MONTICELLO NUCLEAR GENERATING PLANT  
Docket No. 263 License No. DPR-22

Off-Site Shipment of Spent Fuel

RESPONSE TO NRC INFORMAL QUESTIONS  
DISCUSSED DURING MEETING WITH REGULATORY  
STAFF ON APRIL 9, 1976

FIGURE 6-1 (Rev. 1)  
SPENT FUEL CASK  
MOVEMENT PATH

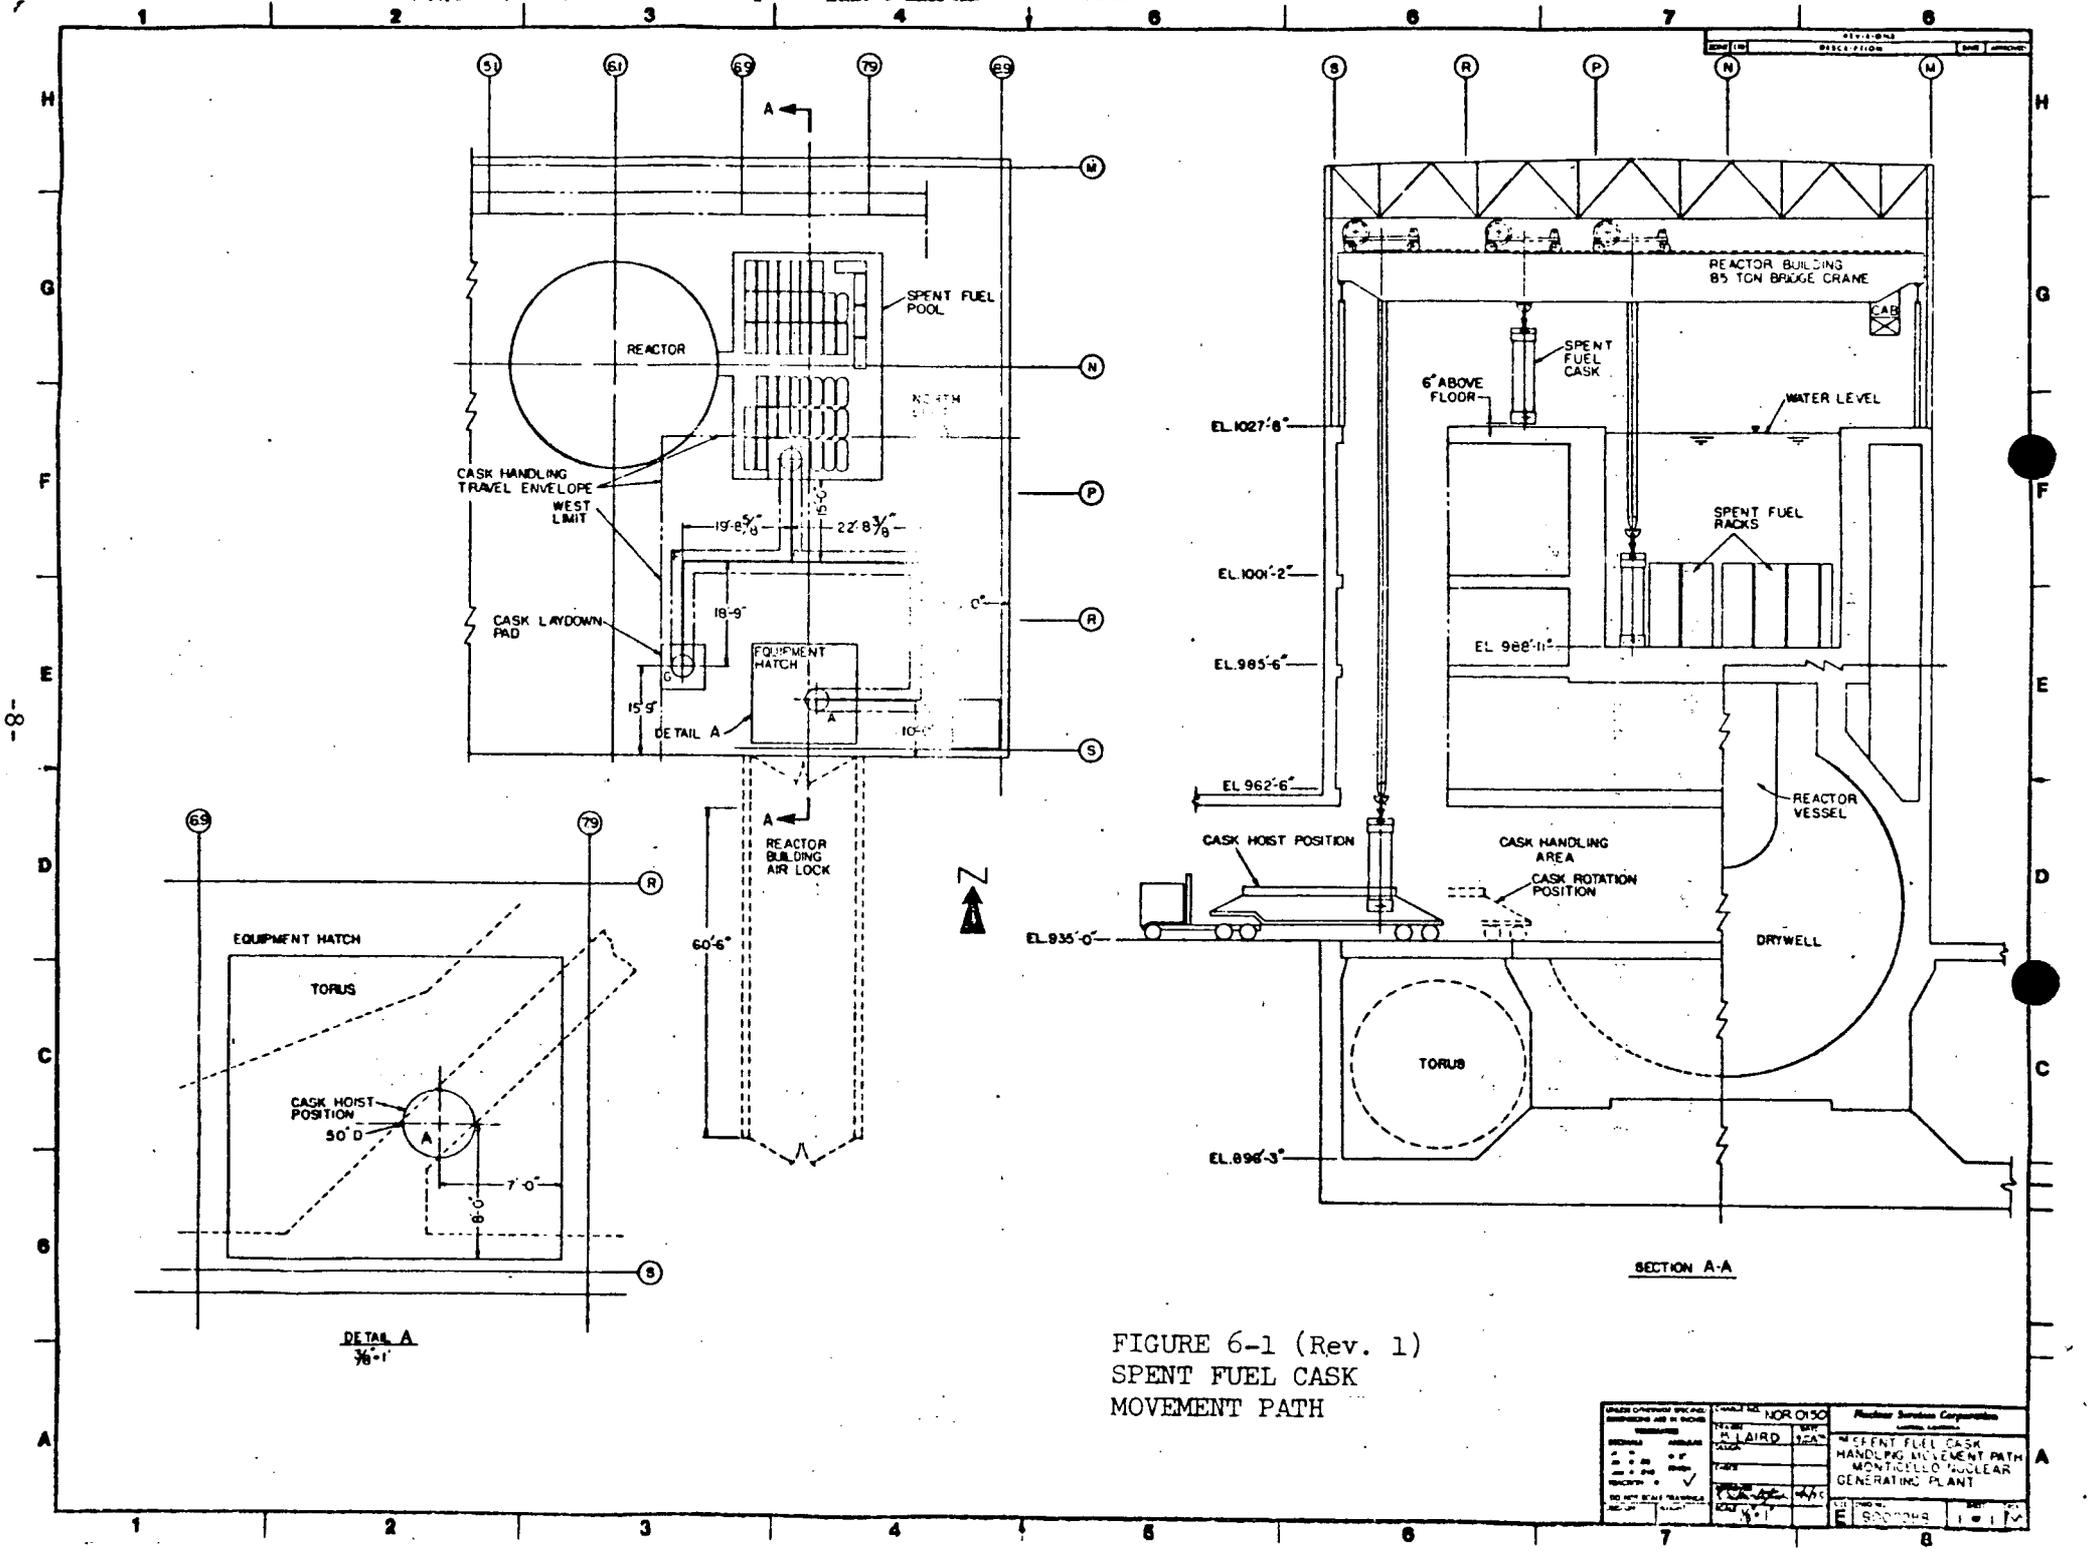
Section 2 of your January 22, 1976 report states "A strictly enforced cask travel path will be employed.....". Section 6.1 states "To ensure movement of the shipping cask along the designated path, floor markings will be made with a bright color as indicated in Figure 6-1 to guide the crane operator and plant personnel during cask handling."

Describe and discuss the possible modifications that could be made to physically limit the cask motions to that depicted in Figure 6-1. Further, indicate the allowable path width under which your analysis of a cask drop remains valid.

Limit switches will be installed on the crane bridges and trolley to preclude cask movement outside of the north and west limits shown on Figure 6-1 (Rev. 1).

A verification was also made to demonstrate that there are no critical drop locations within approximately  $\pm 2$  feet of the designated travel path. The cask will not be permitted to travel near any area which has not been verified for its impact capability.

**FIGURE A-2**  
**SECTIONAL DRAWING OF NFS-4**  
**FUEL SHIPPING CASK**

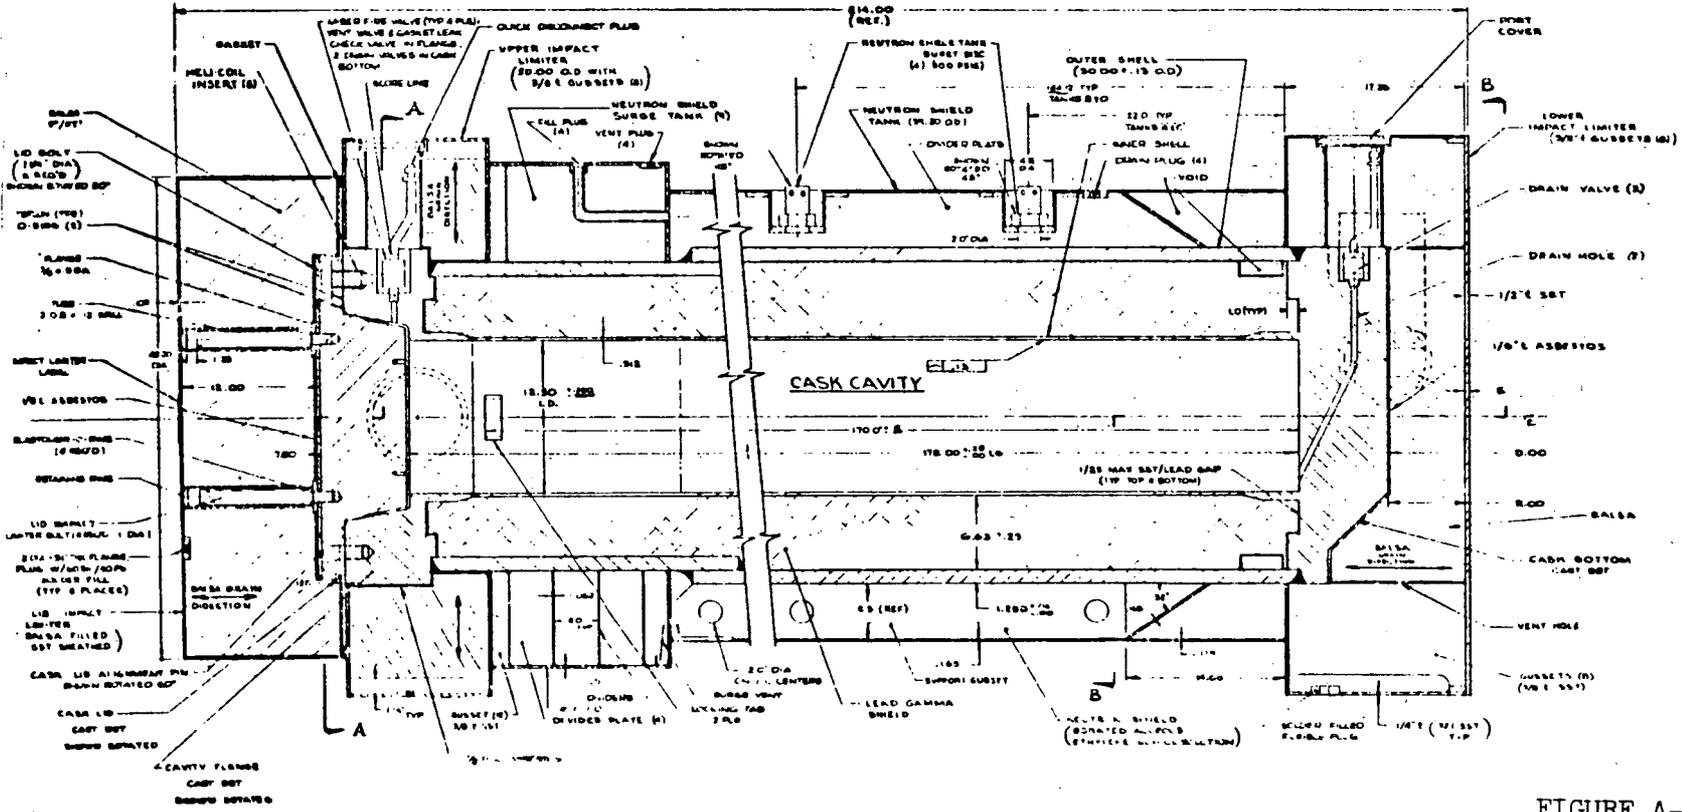
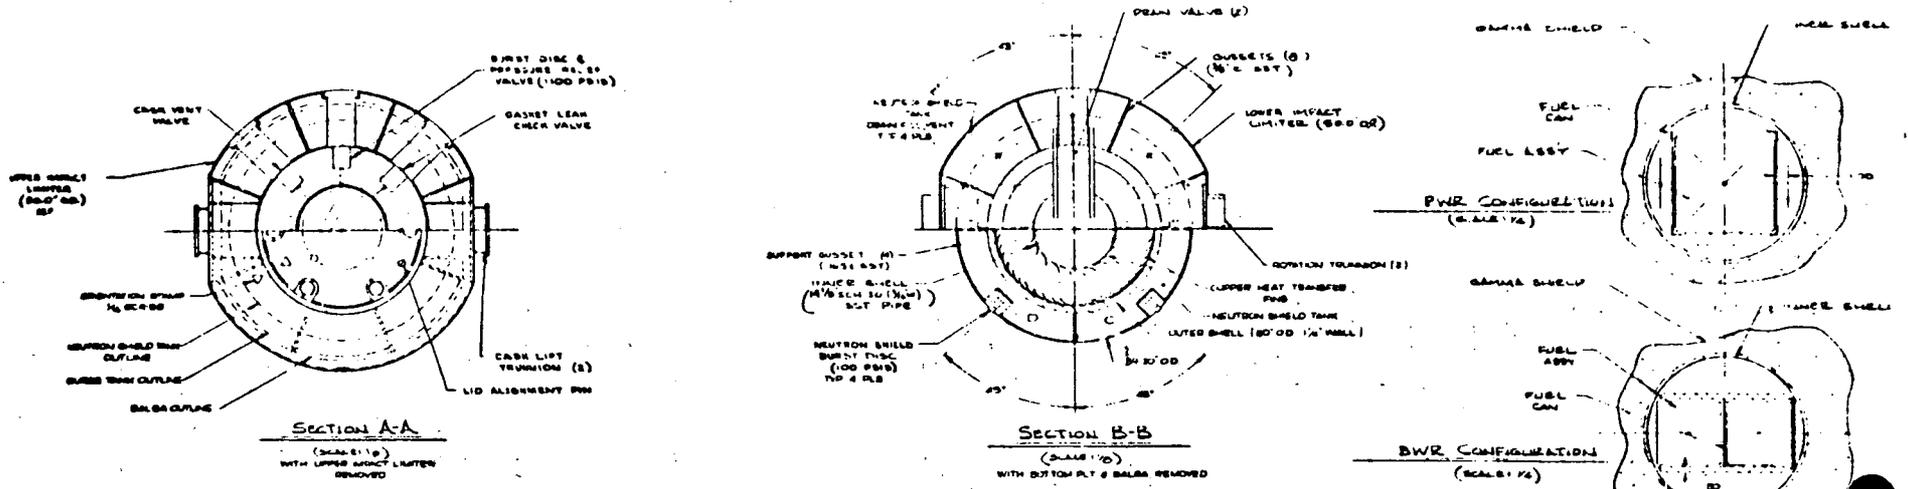
- a. Provide legible individual drawings of the shipping cask showing the lifting trunnions, the handling yoke and the twin sister hook and shackle hole.
- b. Describe and discuss the load carrying capabilities of the shipping cask lifting trunnions, the handling yoke and the point of attachment of the handling yoke to the main hoist twin sister hook.
- c. Modify Table 4-1 by adding the factors of safety for the items identified in (b) above.
- d. Describe and discuss what modifications or means are possible for devising redundant load paths from the shipping cask to the main hoist hook.

- a. Figure A-2, attached, gives a sectional drawing of the NFS-4 cask as described with lifting trunnions included. Figure A-3

The NFS-4 shipping cask is shown in Figure A-2 as submitted with the response to Question 10. The impact limiter device attached to the cask bottom head surrounds the cask body and consists of a 50 inch diameter by 17.25 inch high stainless steel ring with 3/8 inch stainless steel gusset plates filled with balsa wood for impact absorption. The impact limiter is encased in a 1/4 inch shell of stainless steel with a 1/2 inch bottom plate and a 1/2 inch shock tube for impact resistance. This design ensures maintenance of impact limiter integrity during routine handling.

FIGURE 3-7

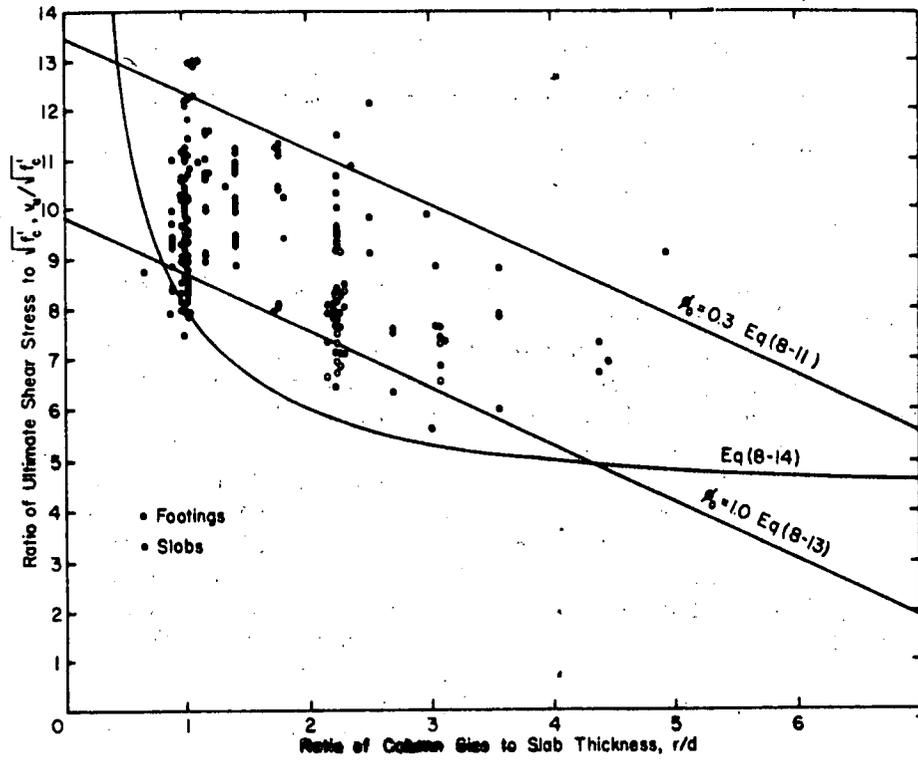
On page 3-8 it is indicated that the force acting on the structure is checked for punching shear and end shear on the slab and beam. Indicate what limits are used to arrive at the acceptance criteria.

Comparison of this equation with an expression developed by Moe from test data (see Reference 7) is reported in Reference 6 and reproduced in attached Figure 3-7. This plot shows the validity of Equation 8-14.
